Access Compliance Report

Public Rights-of-Way

(Curb Ramps)

Intersection ID: 30018	Main Street: W_MALLARD_CREEK_CHURCH_RD	Cross Street: BERKELEY_PLACE_DR	Location: SE
ADA ID: 120F2742501F	Ramp Type: Perp	Initial Pass/Fail: Fail	Overall Compliance: No
Severity Score: 12.5			
Codes/Mitigation Info/Possible Solution		Field Measurements/Component Compliance

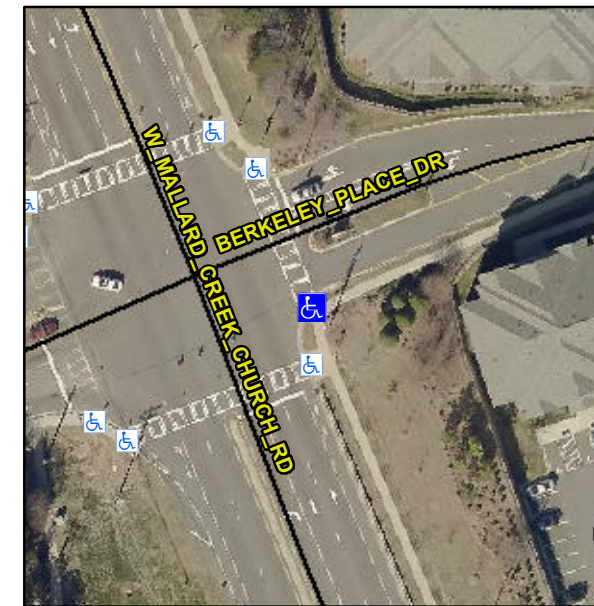
R304.2.2

Compliance	Description	Data	Compliance	Description	Data
N/A	Ramp Length (in)	50.0	No	Ramp Slope (%)	8.6
Yes	Ramp Width (in)	48.0	Yes	Ramp XSlope (%)	1.2
N/A	Flare Type LT	N/A	N/A	Flare Type RT	N/A
N/A	Flare Slope LT (%)	N/A	N/A	Flare Slope RT (%)	N/A
N/A	Flare Traversable LT?	N/A	N/A	Flare Traversable RT?	N/A
N/A	Landing Length (in)	N/A	N/A	DWS Provided?	N/A
N/A	Landing Width (in)	N/A	N/A	DWS Contrast?	N/A
N/A	Landing Slope (%)	N/A	N/A	DWS Length (in)	N/A
N/A	Landing X Slope (%)	N/A	N/A	DWS Full Width?	N/A
N/A	Landing Curb? (Y/N)	N/A	N/A	DWS Offset (in)	N/A
N/A	Shared Landing?	N/A			
N/A	Gutter Ponding?	N/A	N/A	Gutter Slope (%)	N/A
N/A	Gutter Lip Ht (in)	N/A	N/A	Gutter X Slope (%)	N/A
N/A	Painted X Walk1?	Yes	N/A	Painted X Walk2?	N/A
	X Walk 1 Direction	To N		X Walk 2 Direction	N/A
N/A	X Walk 1 Width (in)	113.0	N/A	X Walk 2 Width (in)	N/A
	X Walk 1 Slope (%)	2.7		X Walk 2 Slope (%)	N/A
	X Walk 1 X Slope (%)	3.8		X Walk 2 X Slope (%)	N/A

Remove & Replace Entire Ramp.
